September 2, 2021

RE: **1-MP-2021**
Fiesta Ranch
3380C (Key Code)

The Planning & Development Services Division has completed the review of the above referenced development application submitted on August 3, 2021. The following **1st Review Comments** represent the review performed by our team and is intended to provide you with guidance for compliance with city codes, policies, and guidelines related to this application.

MAXIMUM DWELLING UNITS/MAXIMUM DENSITY. Maximum dwelling units and maximum density shall be as indicated on the Land Use Budget Table below.

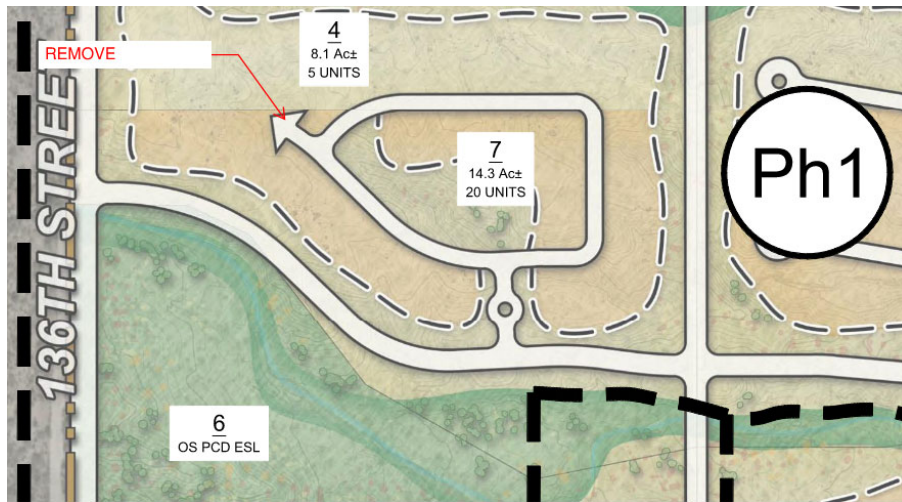
3. On Page 3 of the Master Environmental Design Concept Plan map has different number of units in the Parcels than the stipulated Land Use Budget Table for case 6-ZN-2019 (see below). The stipulations on case 6-ZN-2019 allows for redistribution, but the proposed total number units for the R1-43 areas and the R1-18 areas must be the same number of proposed units. Revised plan has 63 R1-43 units and the stipulated table has 59 R1-43 proposed units. Please revise map and table to comply.
